**Stantec Consulting Services Inc.**  
12080 Corporate Parkway, Suite 200  
Mequon WI 53092-2661

December 2, 2022  
File: 193707141

**Reference: Response to Request for Additional Information #2; Materials Management Plan and Ch. NR 718 Exemption Request for C. Reiss Coal Dock Property, Superior, Wisconsin, BRRTS Case No. 02-16-589248**

SURVEY	JN
DRAWN	AJR
DESIGNED	AJR
CHECKED	AJR
APPROVED	AJR
PROJ. NO.	193707141

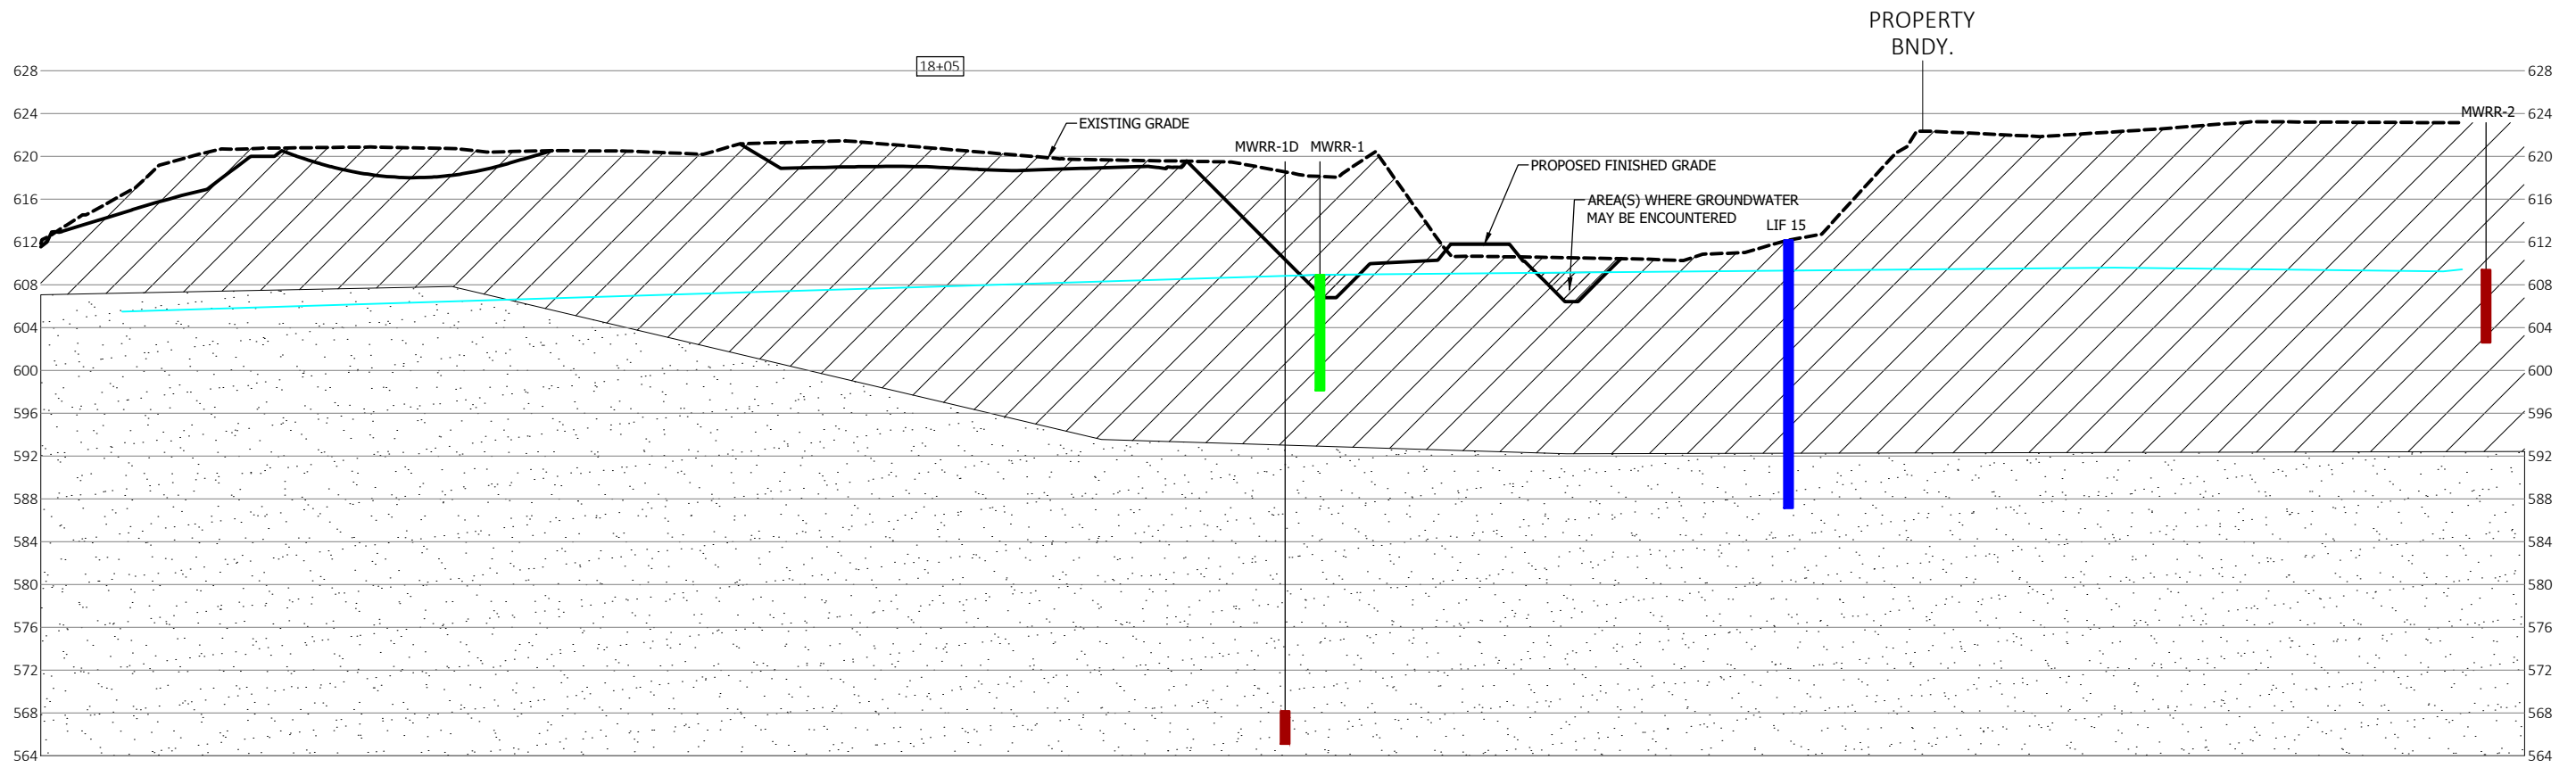
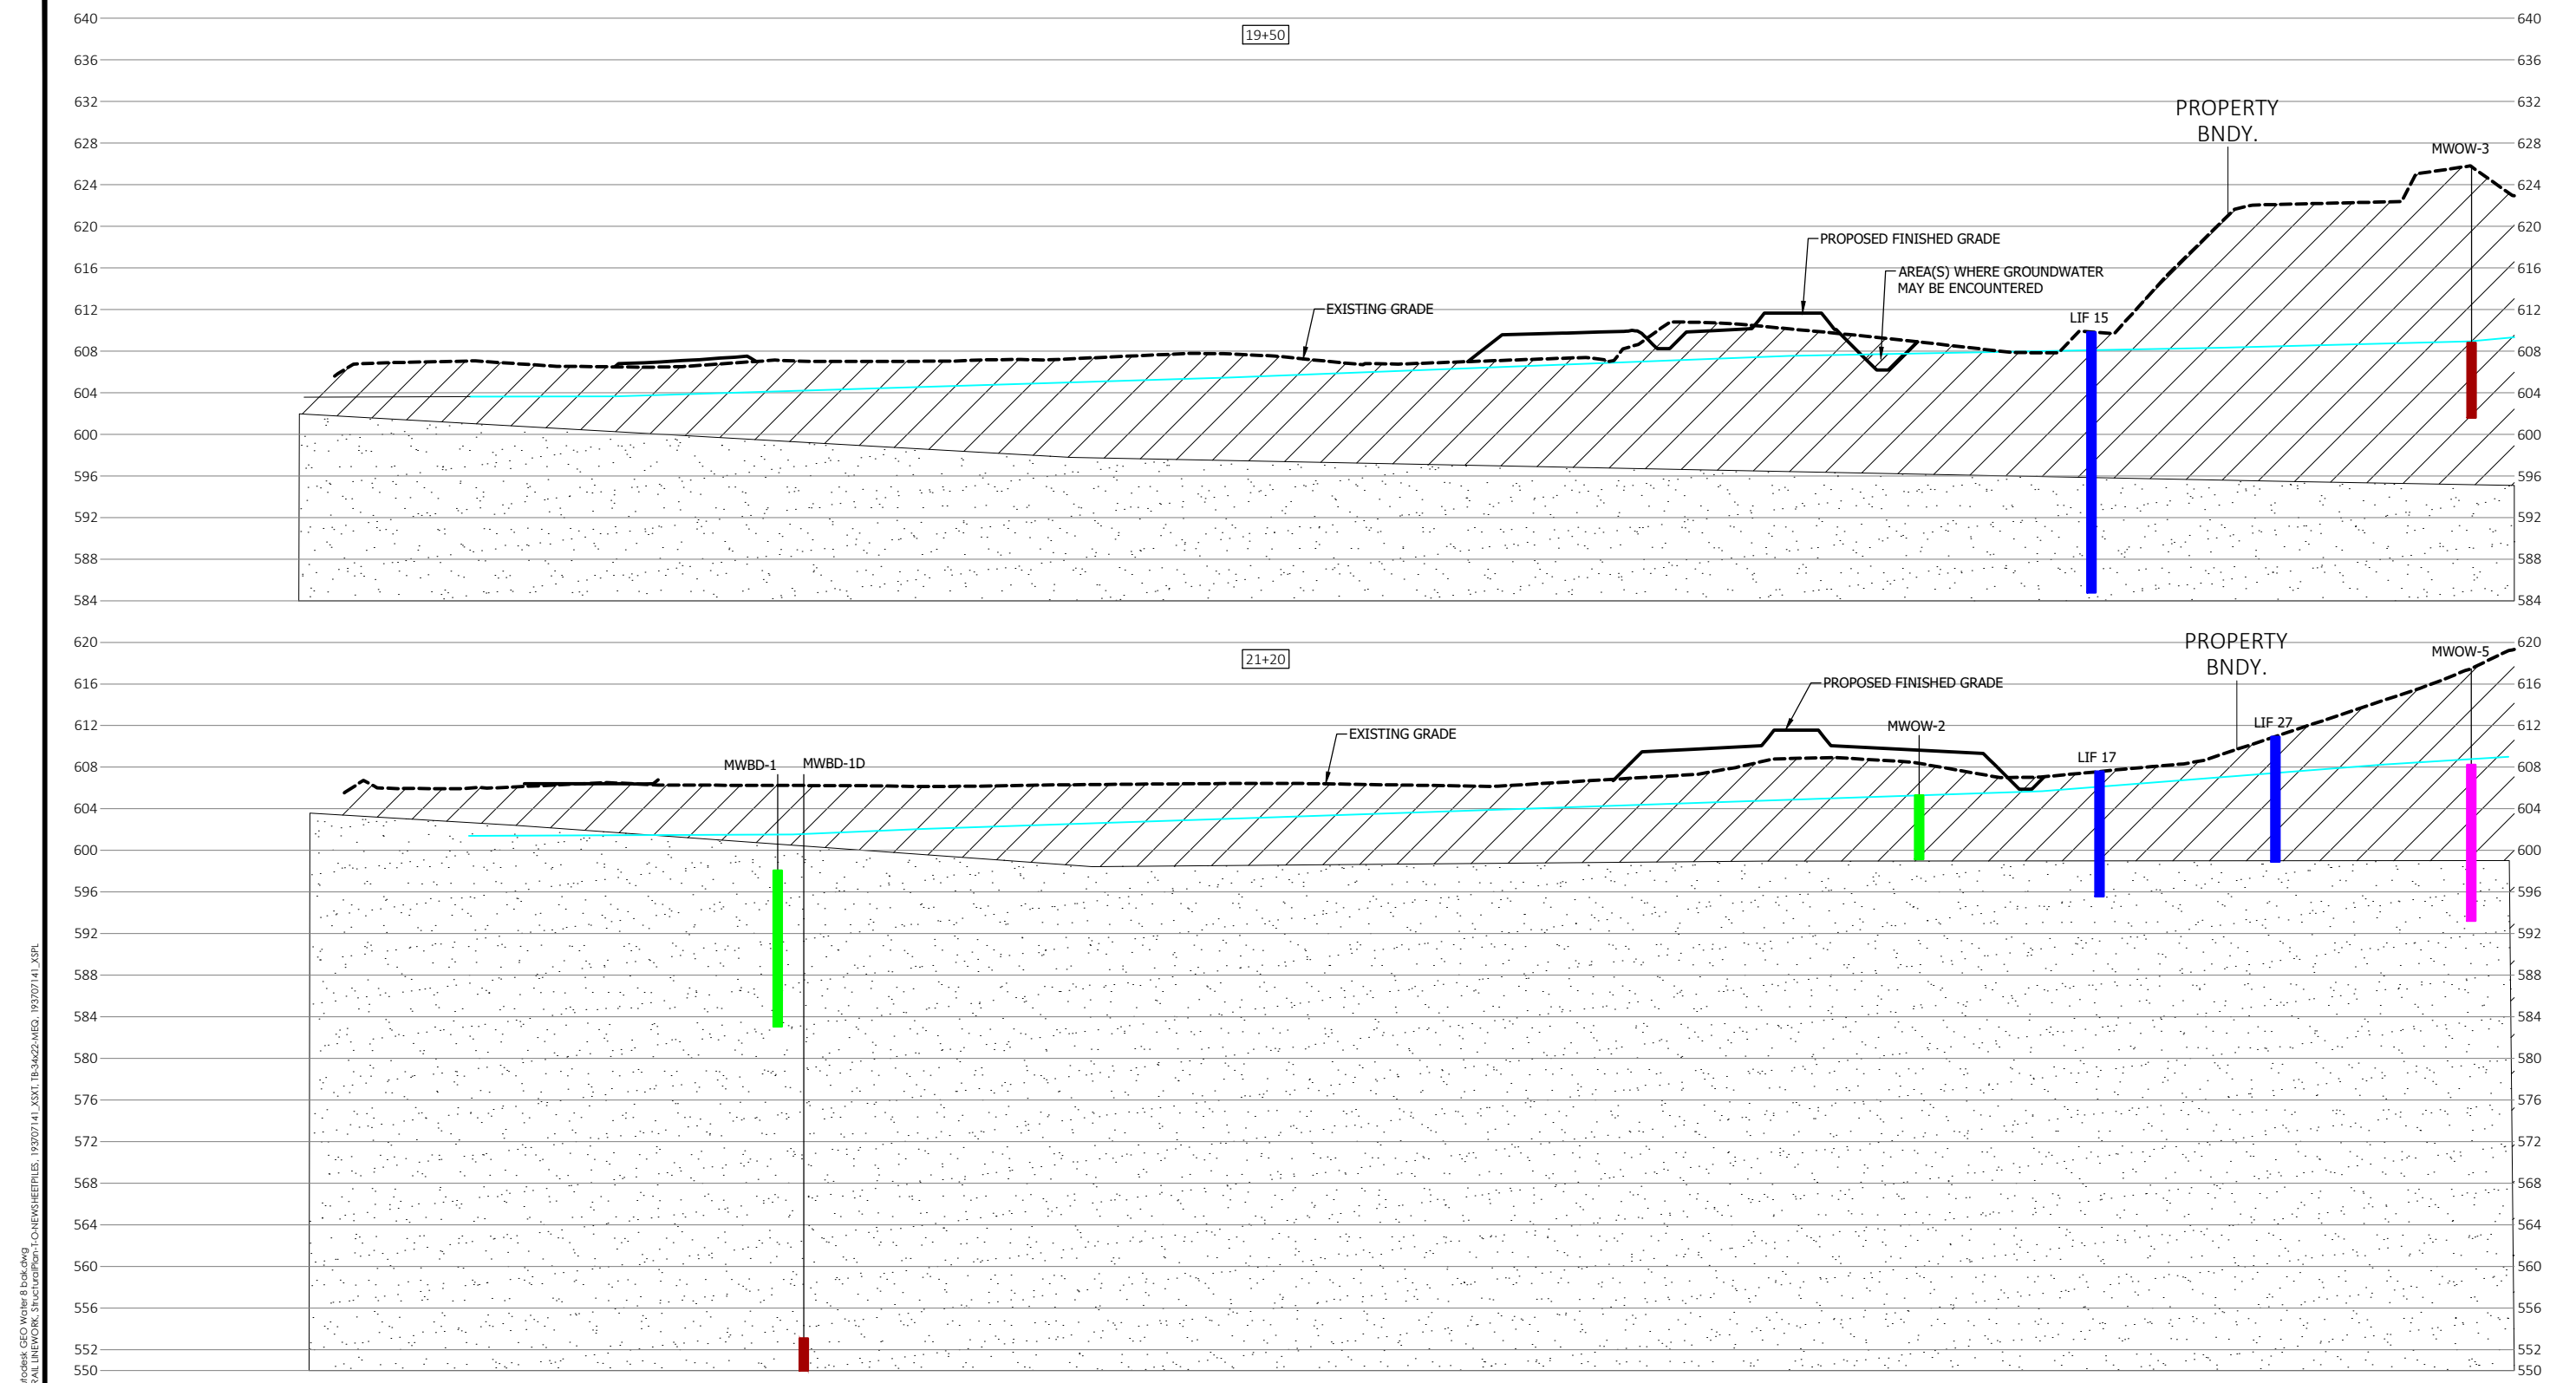
**2. The RR grade and stormwater pond call for excavating site soils, extending into the confining clay layer, and potentially breaching the clay layer. This, combined with the placement of large volumes of soil and sediment adjacent to these excavated areas, could impact the hydrogeologic conditions at the site. There needs to be an evaluation of both the geotechnical and hydrogeological aspects of the proposed excavation and placement of material. To what extent will the proposed activities impact groundwater conditions, including the migration of contaminated groundwater and LNAPL? Do you anticipate the potential migration of contaminated groundwater and LNAPL to the surface in excavated areas? In what other ways will site hydrogeological conditions be impacted by the proposed placement and excavation of material?**

**3. Contaminated groundwater and LNAPL on the adjacent property to the east are not shown in figures 7 & 8.**

**Clay unit.** The cross sections provided on **Figure 8** have been updated to illustrate the approximate depth/thickness of the clay unit present across the Property and depth of the underlying sand/silty sand based on available lithologic information collected by Stantec and others (AET, Antea Group

[Antea] to date. As illustrated on **Figure 8**, the maximum depth of cut is above the clay/sand interface for the majority of proposed Property redevelopment. The only areas where the proposed excavations will breach the clay unit and extend approximately 1 to 1.5 feet into the underlying sand/silty sand are at Stations 11+75 and 15+10. This area is far north of the LNAPL finger plume, and west of the smaller LNAPL plumes on the east-adjointing Property which (as discussed above) are limited in nature and not anticipated to impact proposed property excavations. Therefore, no mobilization of LNAPL or contaminated groundwater is anticipated as part of proposed Property excavations.

**Response:** **Figures 7 and 8** have now been updated to include available groundwater and LNAPL information on the parcels adjacent to the Property (including the east-adjointing property) and are included as attachments to this submittal.

As discussed in Response #2, LIF data available for the Property in areas near the smaller LNAPL plumes present along the east-adjointing property (north of the “finger plume”) have also been added to **Figures 7 and 8** to illustrate that LNAPL impacts from these smaller plumes are limited in nature and are not anticipated to impact Property construction.

### Soil Quality - Profile View

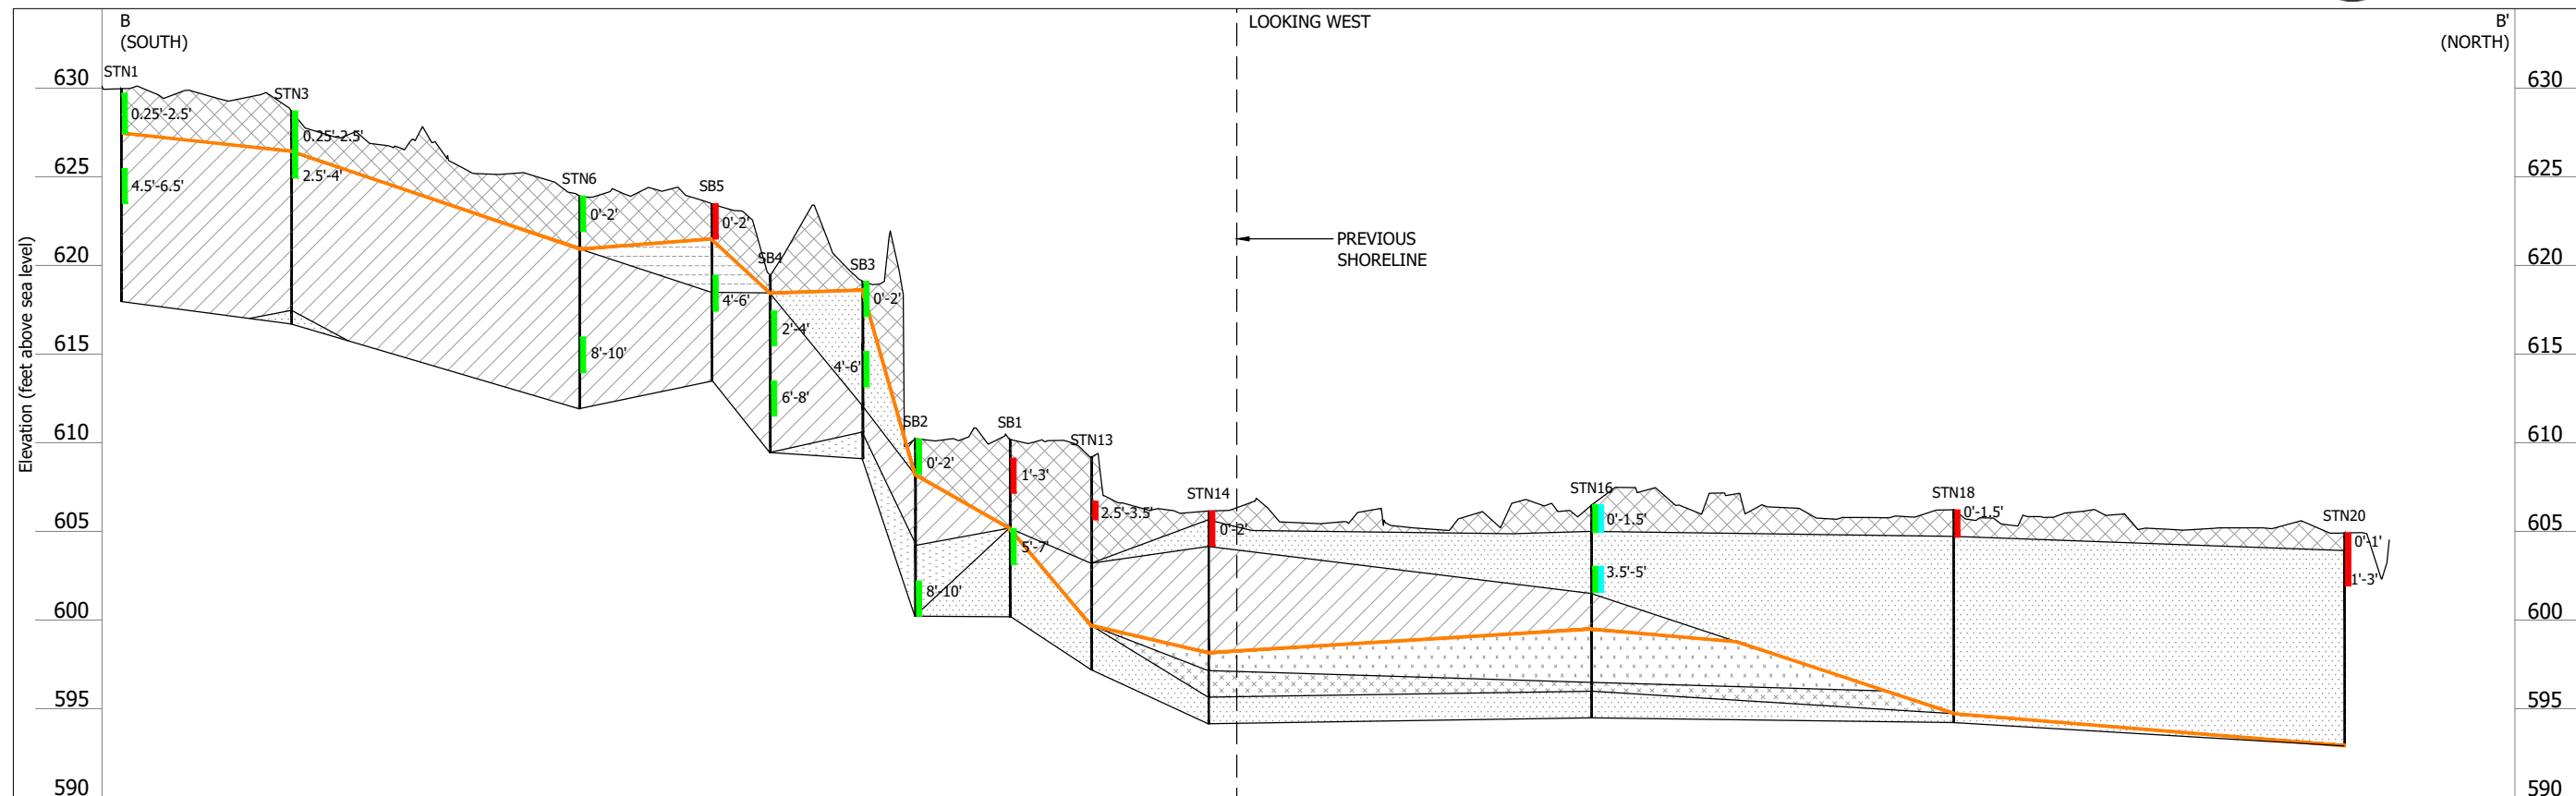
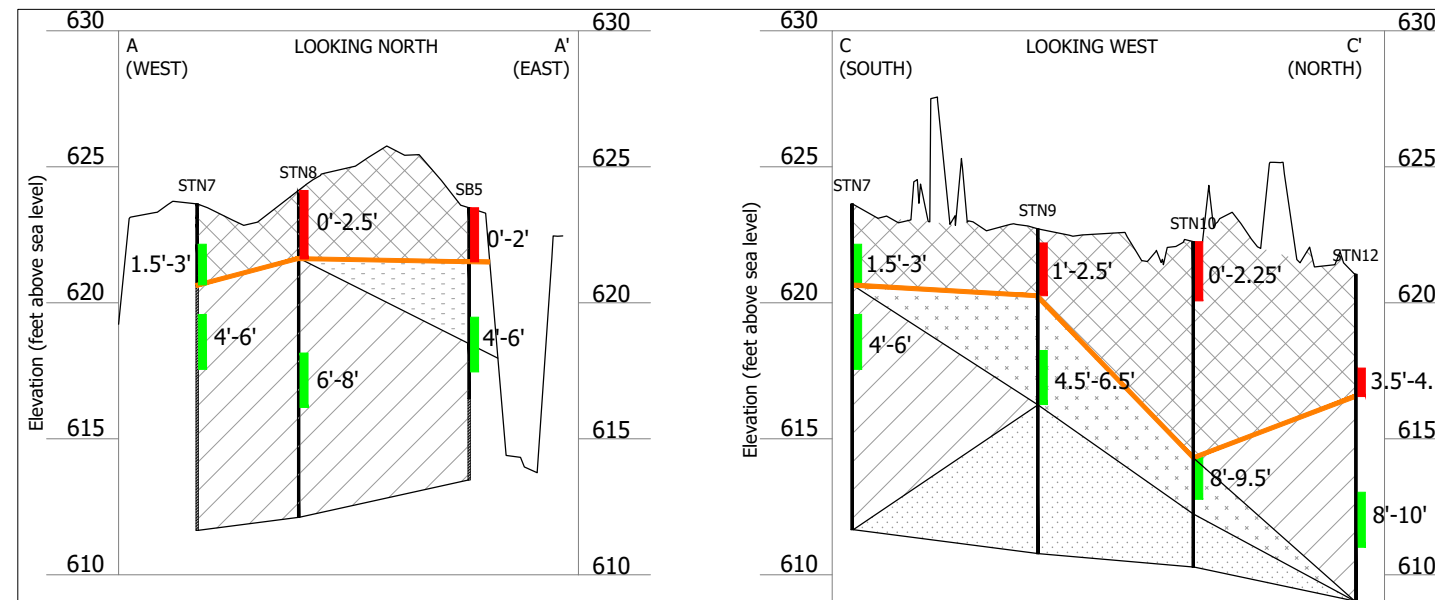
**7. The soil quality – profile view in Figure 11 is distorted since the cross-section excludes locations STN9 and STN10 with the highest PAH contamination levels.**

**Response:** **Figure 11** has been updated to include a section view through STN9 and STN10 as C – C' for clarity pursuant to this request and displays contaminant trends consistent with sections A – A' and B – B' (with PAH impacts at concentrations greater than NR 720 industrial direct contact RCLs limited to fill, and with no such impacts to underlying native soils).
